Lagoon Design Approval and Photo Sheet

Southall Western Access

*Lagoon Temporary Stockpile
Appraisal – Revision 2*

A720-E05-IW-CGL-EW-RP-0002

SCHEMATIC LONG SECTION THROUGH LAGOON STOCKPILES

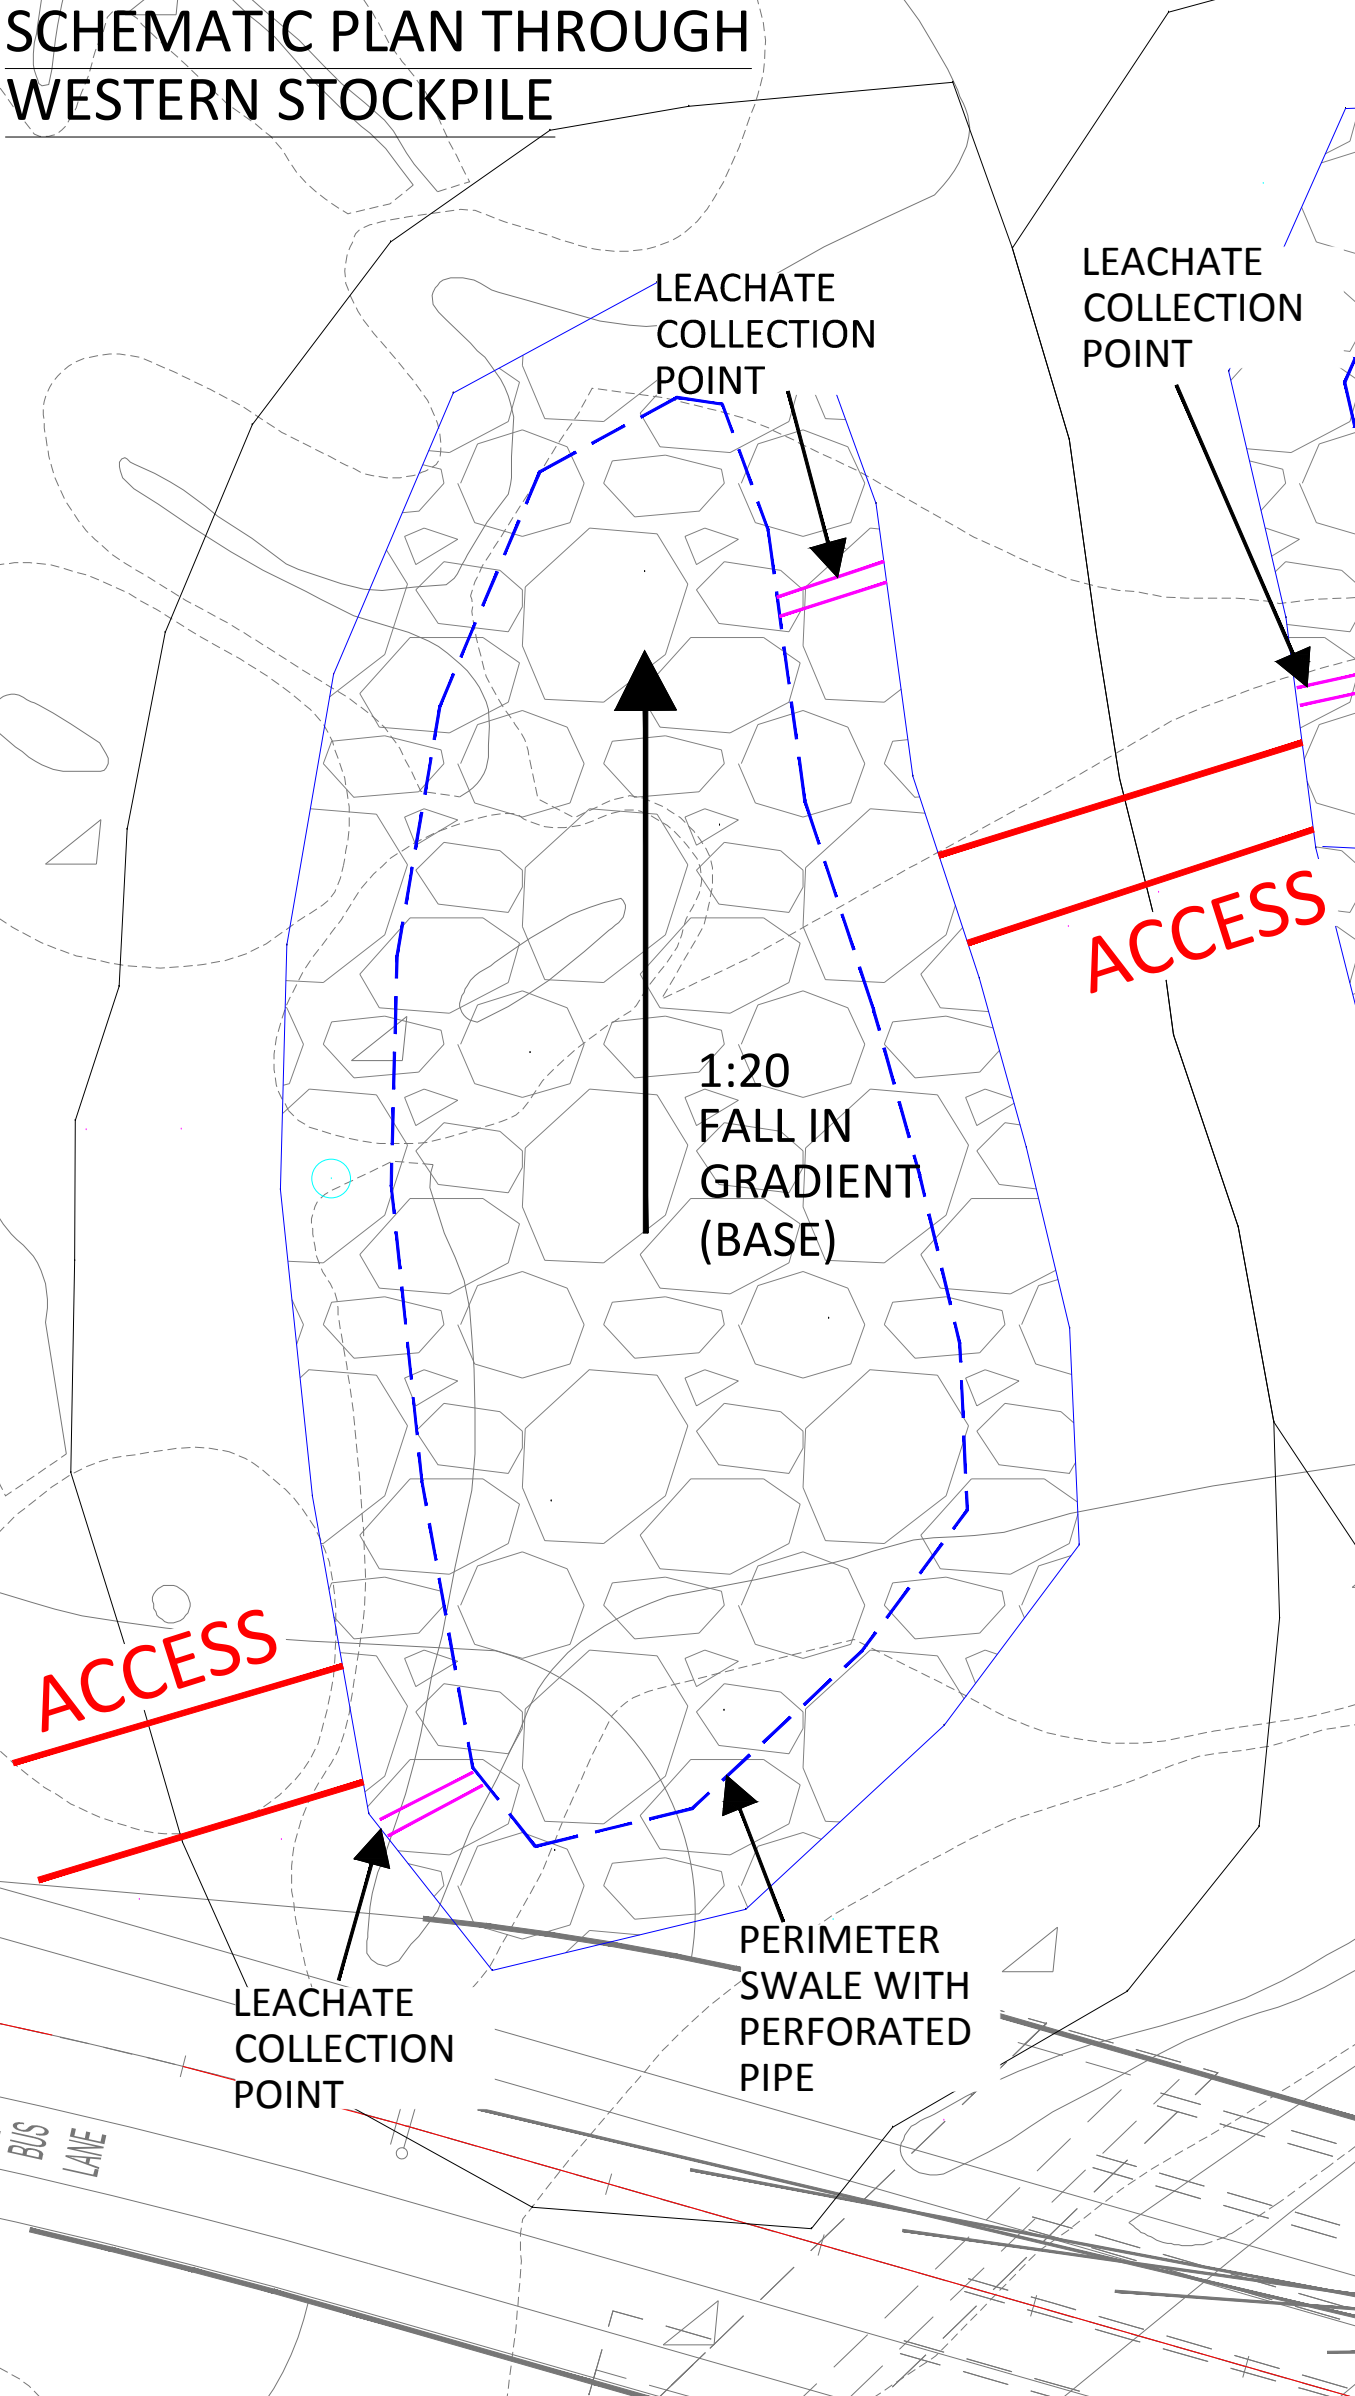
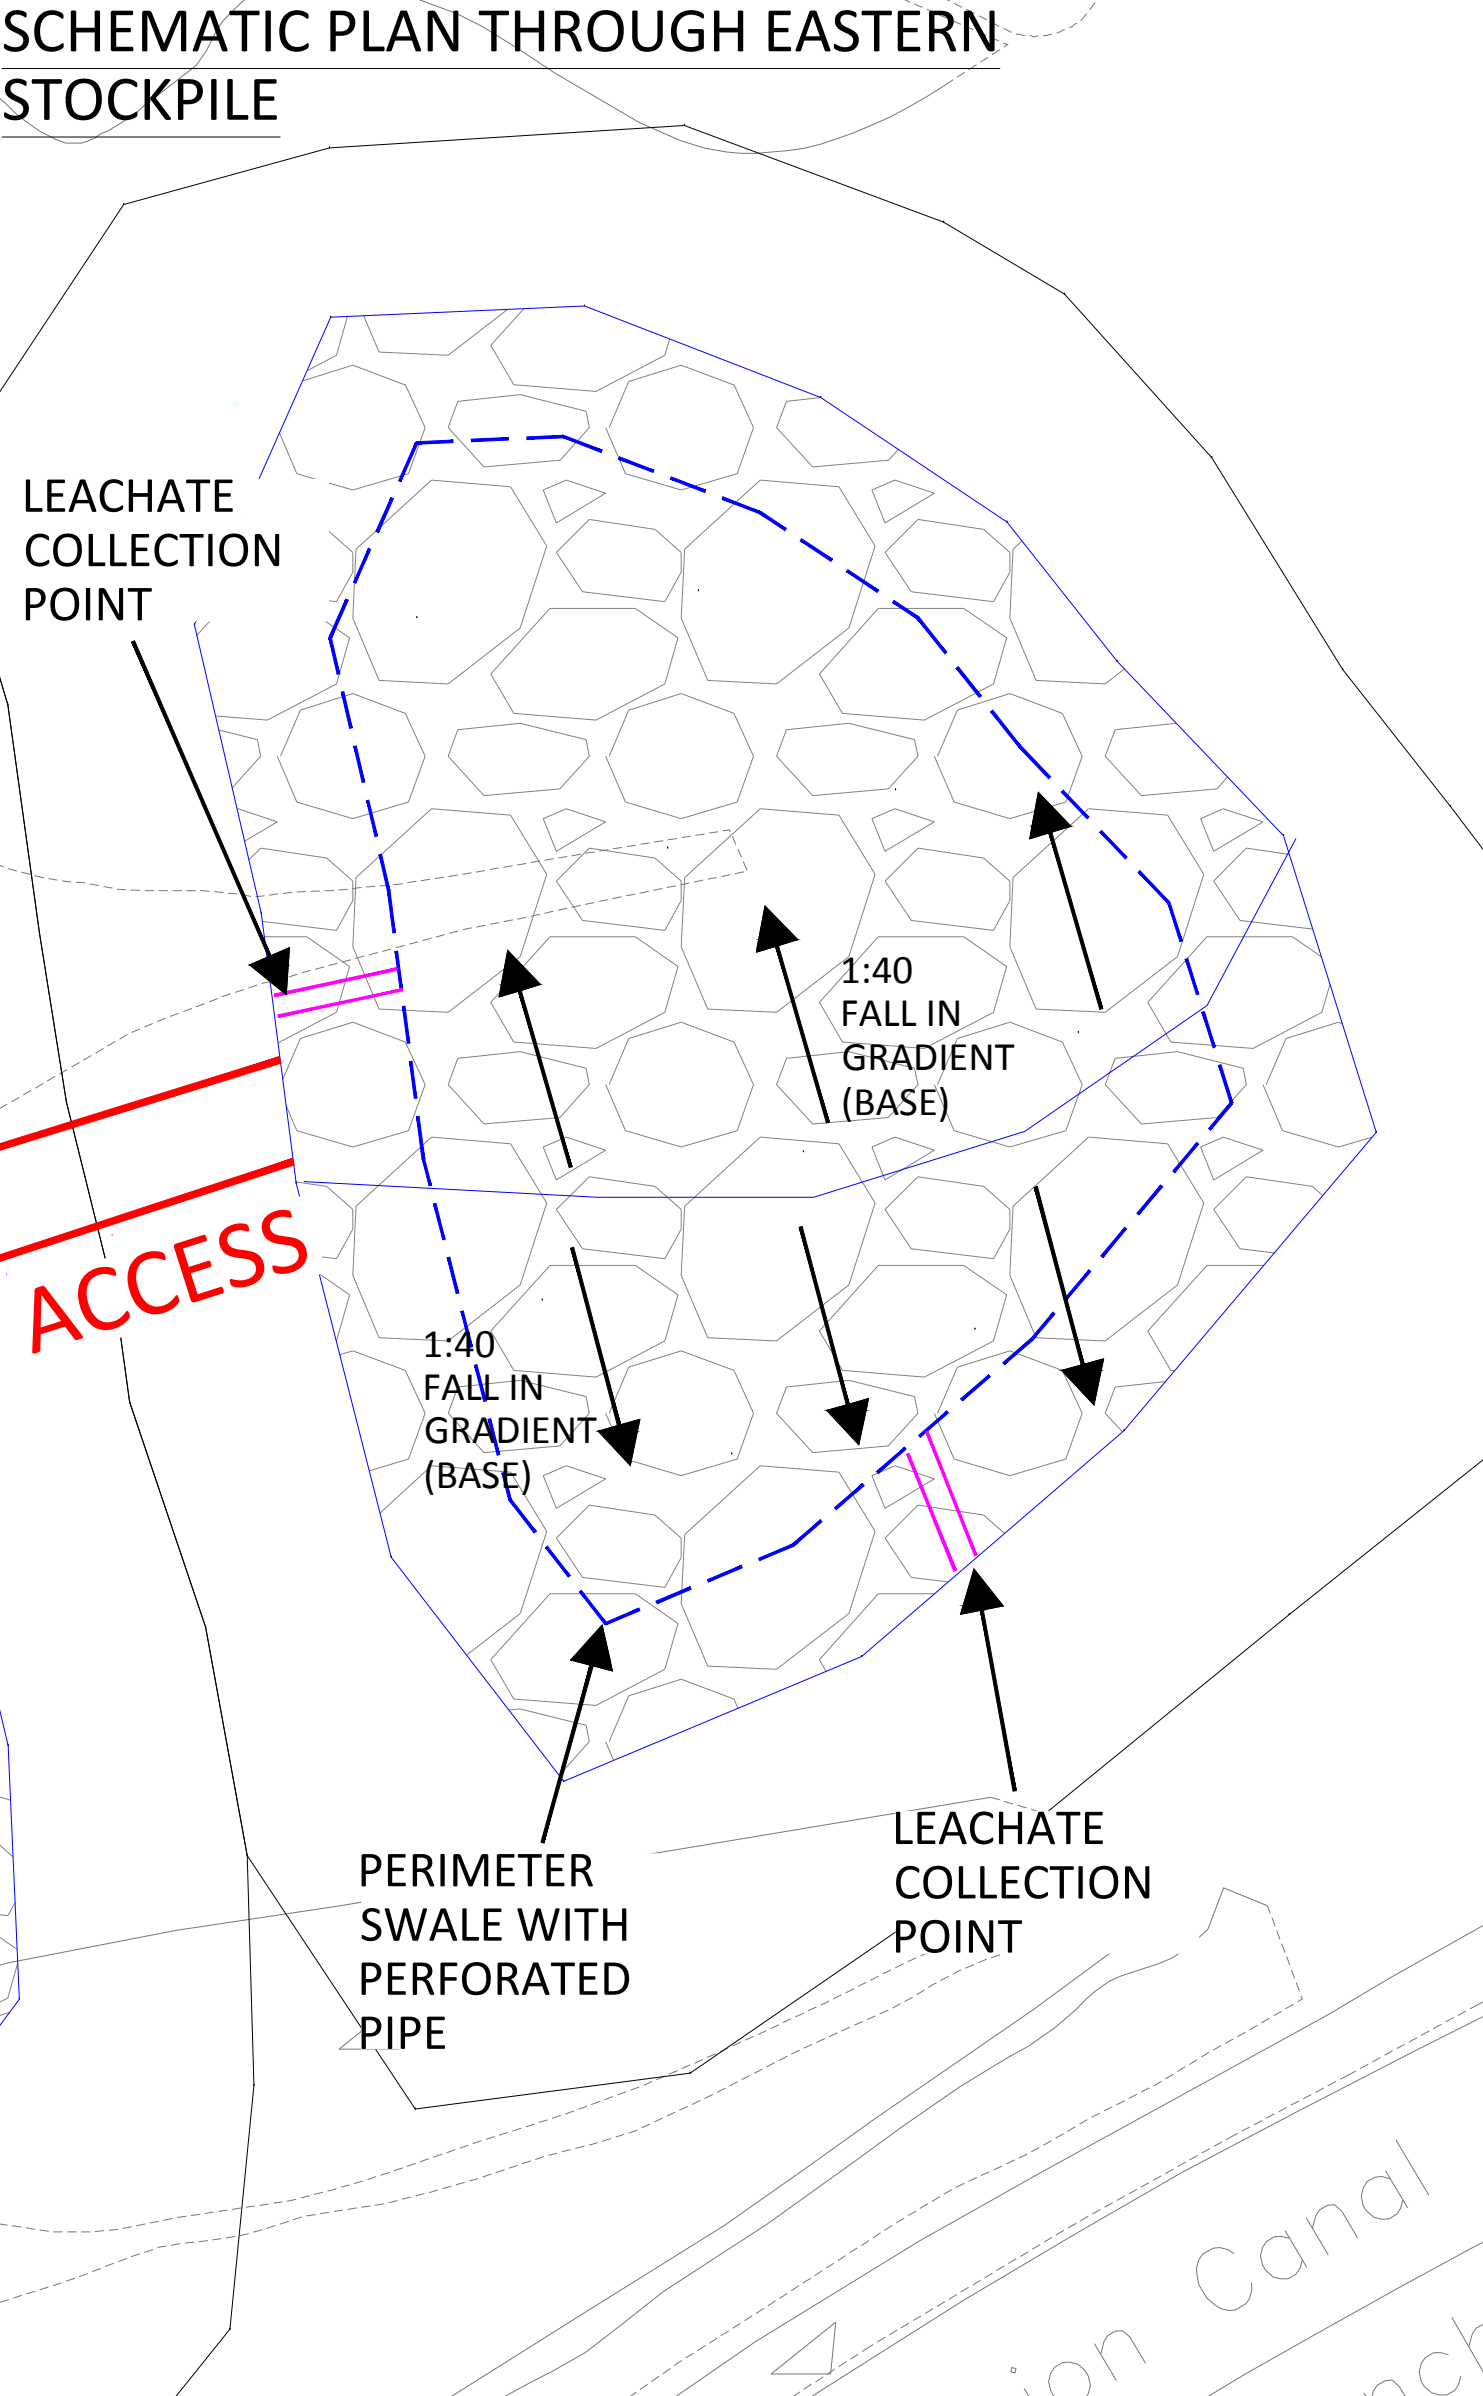
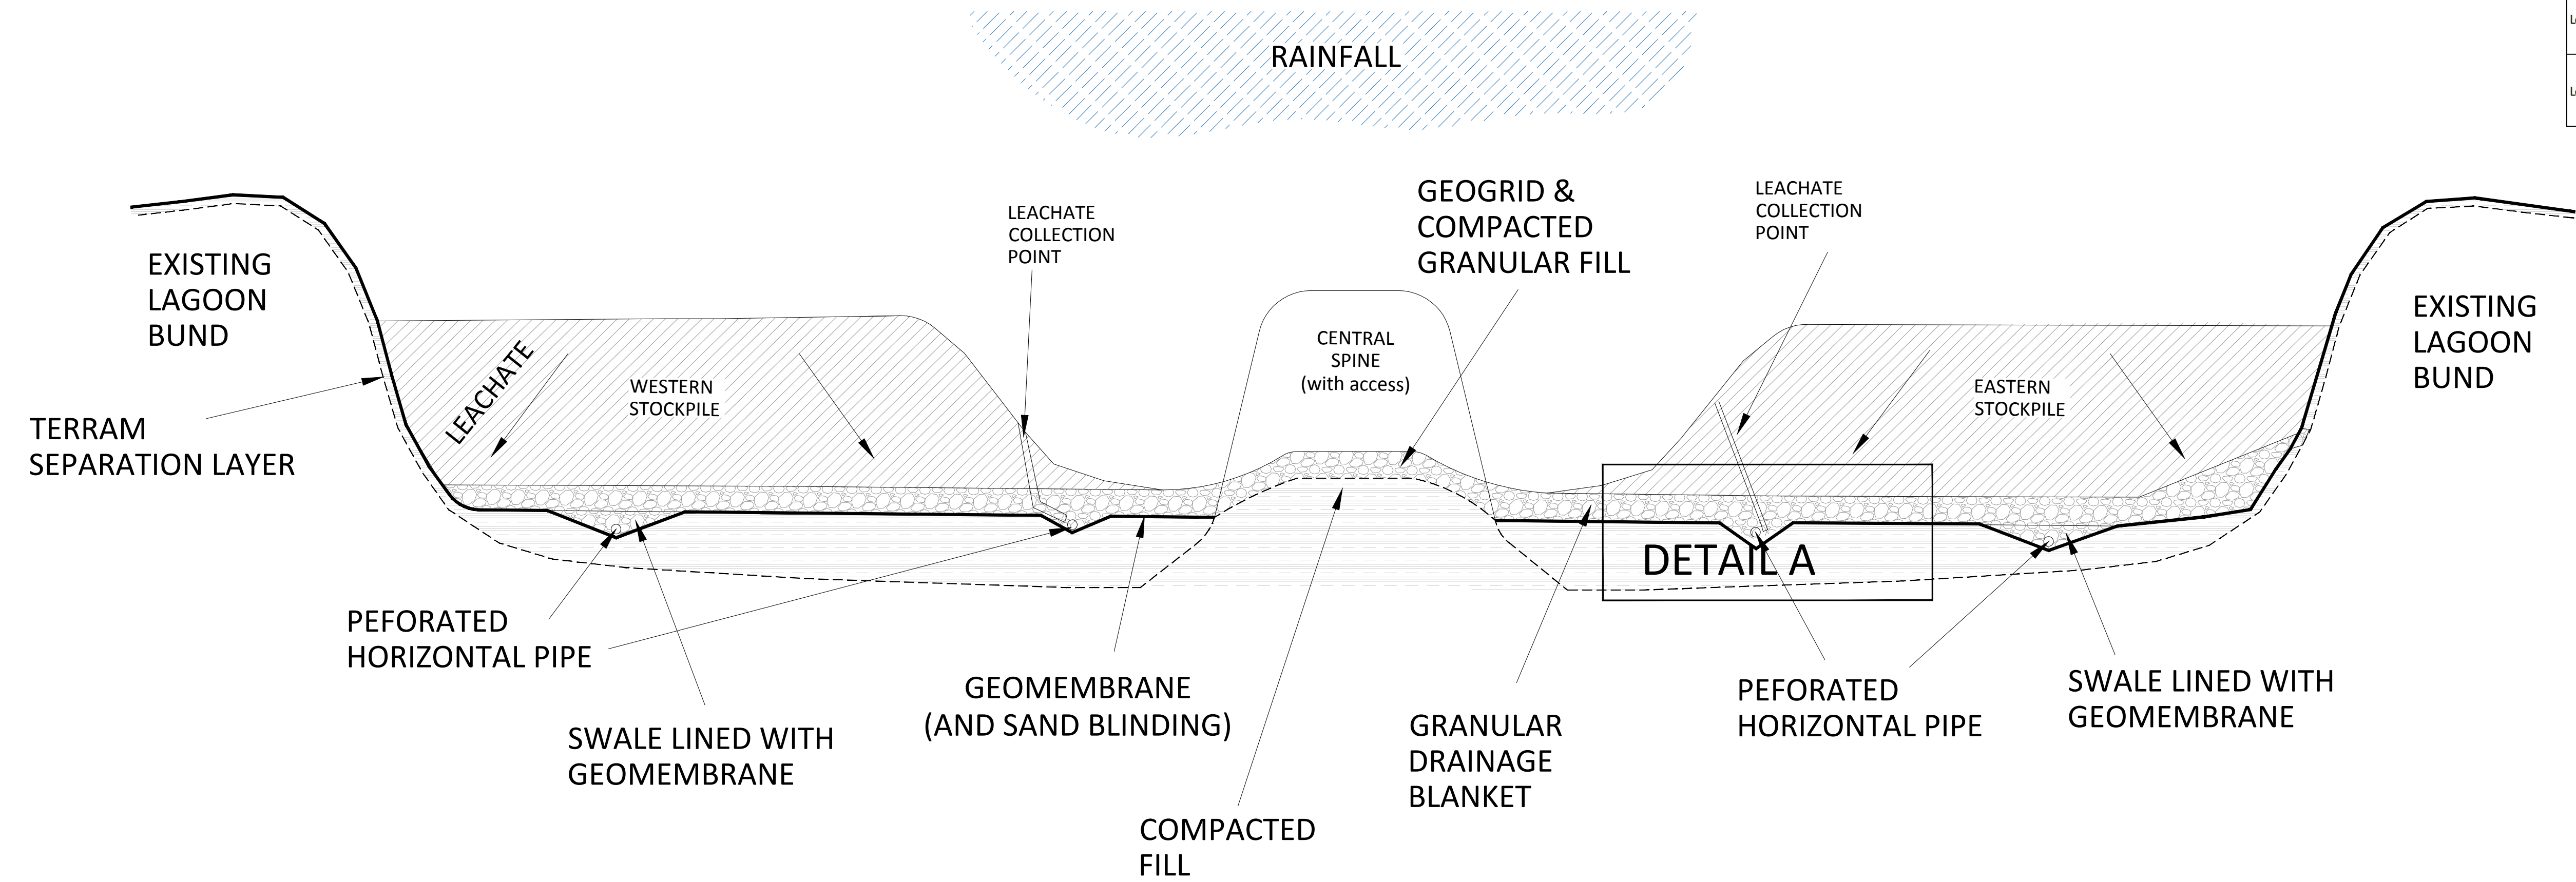
We have reviewed the revised schematic section of the proposed lagoon area stockpile and we are now comfortable with the general arrangement of the for the temporary stockpiling of excavated materials.

We have the following comments regarding the management of leachate within the stockpiles:

- We note that the sumps will be pumped weekly and following rainfall based on an assumed average monthly rainfall of 93mm per month. Can you please confirm that, in the event of an unusually heavy rainfall event, resource provision exists to ensure that leachate is pumped out and disposed of off-site in a timely manner.
- Can you confirm the leachate collection points will be protected to avoid them being damaged by plant operating in the stockpile area.

- 1) The Leachate Collection points will be suitably fenced off (pedestrian barriers) so they are protected from damage by plant/vehicles.
- 2) In the event of unusually heavy rainfall the sumps will be pumped out more frequently as necessitated by the rain situation. There will be spare pumping capacity stored on site for such an eventuality.

Trust this answers the 2 No queries from EA
